**Well Name:** POKER LAKE UNIT 28-21  
BS MON **POW****Well Location:** T25S / R31E / SEC 28 /  
NENE /**County or Parish/State:****Well Number:** 108H**Type of Well:** CONVENTIONAL GAS  
WELL**Allottee or Tribe Name:****Lease Number:** NMLC0062140A**Unit or CA Name:** POKER LAKE**Unit or CA Number:**  
NMNM071016X**US Well Number:****Well Status:** Approved Application for  
Permit to Drill**Operator:** XTO PERMIAN  
OPERATING LLC

### Notice of Intent

**Procedure Description:** \*\*Name Change, Spacing, Casing/Cement, Drilling Variance Changes XTO Permian Operating, LLC requests permission to make the following changes to the original APD: XTO Permian Operating, LLC. requests to make this a monitoring well to collect formation pressure responses in establishing greater understanding of parent/child relationships between wellbores. This data is beneficial for Poker Lake Unit to assist in an accelerated understanding of the number of wells and spacing configurations required to optimize Federal oil and gas mineral development throughout the unit. The monitoring well will either be converted to a producer or be plugged within 5-years of drill or when downhole gauges are no longer r

## WELL LOCATION AND ACREAGE DEDICATION PLAT PRE-COMPLETION

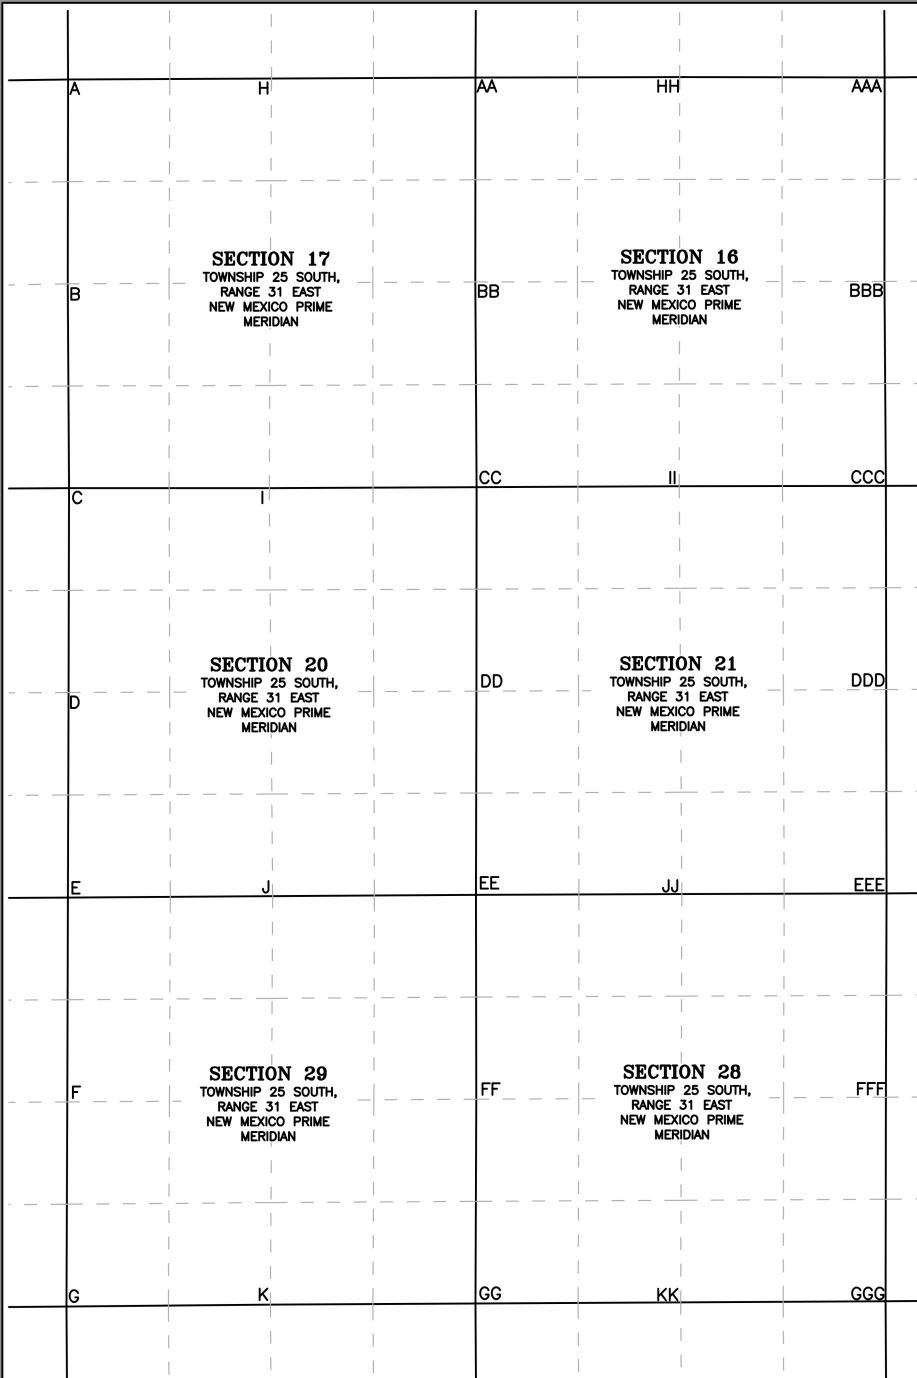
<sup>1</sup> API Number 30-015-48974		<sup>2</sup> Pool Code 98210		<sup>3</sup> Pool Name Stratigraphic	
<sup>4</sup> Property Code <del>331529</del> 331799		<sup>5</sup> Property Name POKER LAKE UNIT 28-21 BS MON POW			<sup>6</sup> Well Number 108H
<sup>7</sup> OGRID No. 373075		<sup>8</sup> Operator Name XTO PERMIAN OPERATING, LLC			<sup>9</sup> Elevation 3,349'

<sup>12</sup> Dedicated Acres 0	<sup>13</sup> Joint or Infill	<sup>14</sup> Consolidation Code	<sup>15</sup> Order No.
			Well is a Non-Producer; Monitoring Well

13-3/8" x 9-5/8" x 5-1/2" 10M RSH-2 Wellhead  
Assembly, With T-EBS-F Tubing Head

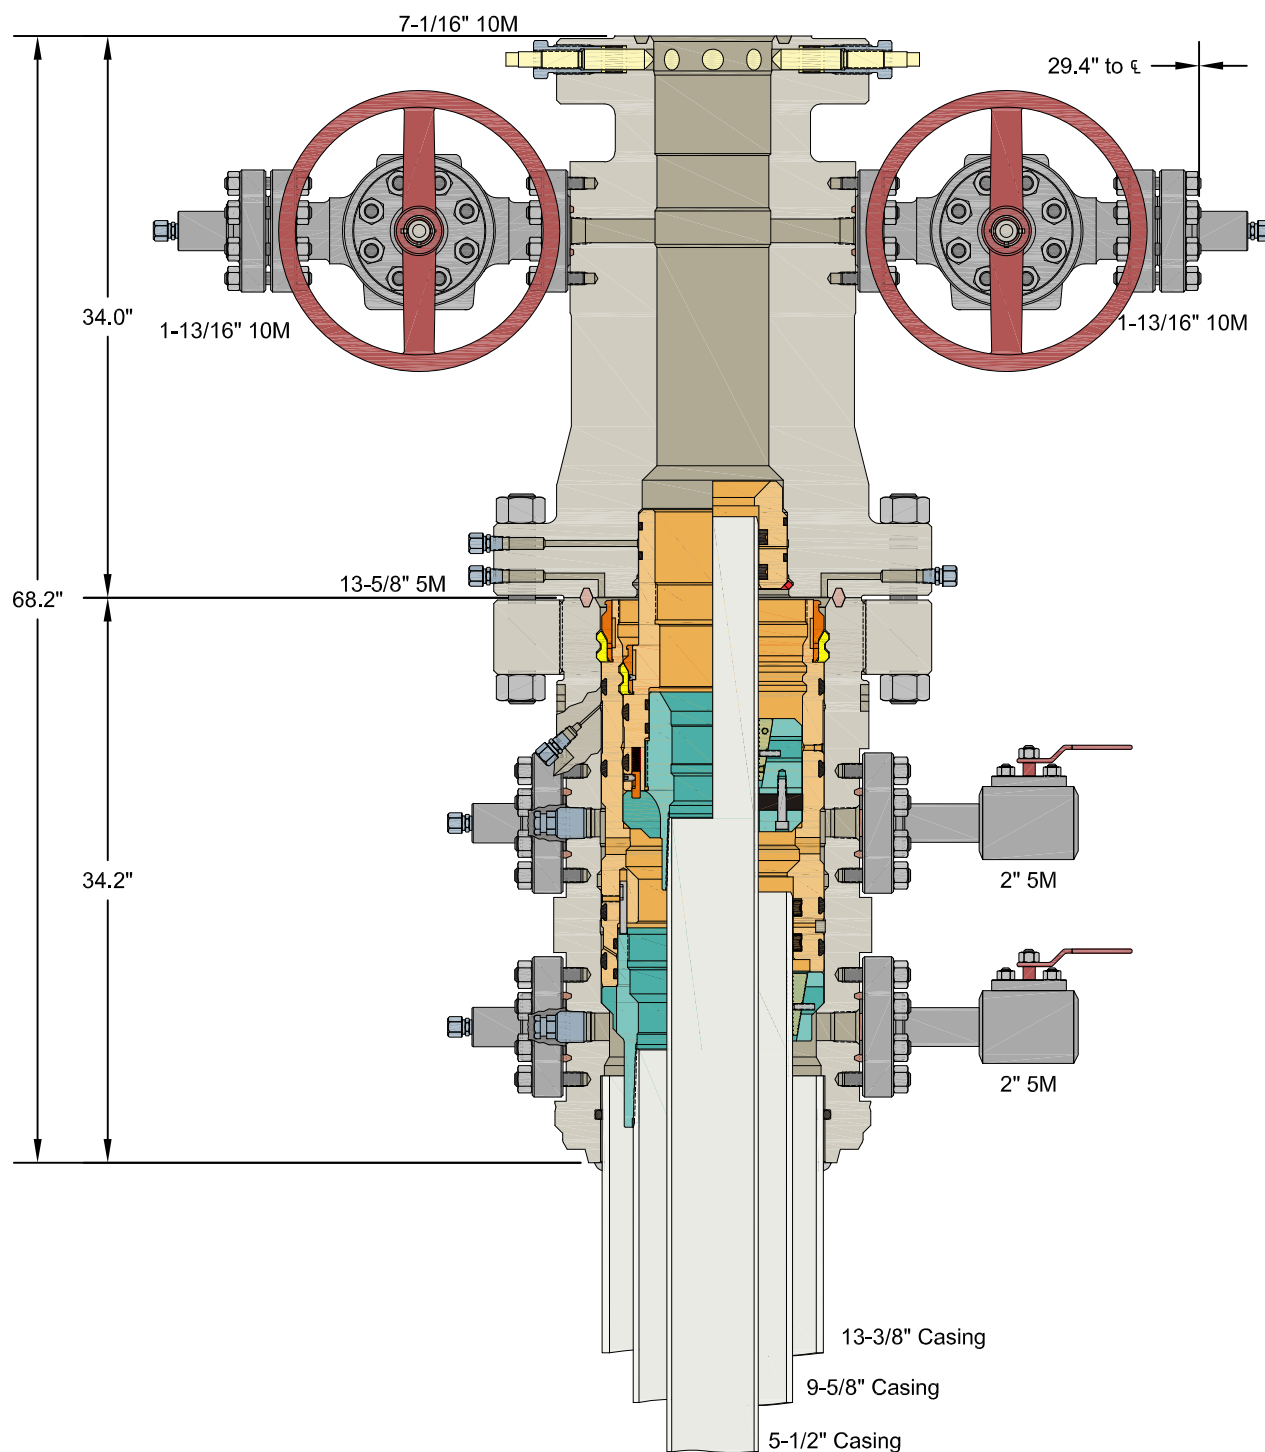
*Permanent Wellhead – Multibowl System*

A. Starting Head: 13-5/8" 10M top flange x 13-3/8" SOW bottom

B. Tubing Head: 13-5/8" 10M bottom flange x 7-1/16" 15M top flange

- Wellhead will be installed by manufacturer's representatives.
- Manufacturer will monitor welding process to ensure appropriate temperature of seal.
- Operator will test the 7-5/8" casing per BLM Onshore Order 2
- Wellhead Manufacturer representative will not be present for BOP test plug installation

1. Operator has proposed a multi-bowl wellhead assembly. This assembly will only be tested when installed on the surface casing. Minimum working pressure of the blowout preventer (BOP) and related equipment (BOPE) required for drilling below the surface casing shoe shall be **5000 (5M)** psi.

- a. Wellhead shall be installed by manufacturer's representatives, submit documentation with subsequent sundry.
  - b. If the welding is performed by a third party, the manufacturer's representative shall monitor the temperature to verify that it does not exceed the maximum temperature of the seal.

- c. Manufacturer representative shall install the test plug for the initial BOP test.
  - d. If the cement does not circulate and one inch operations would have been possible with a standard wellhead, the well head shall be cut off, cementing operations performed and another wellhead installed.
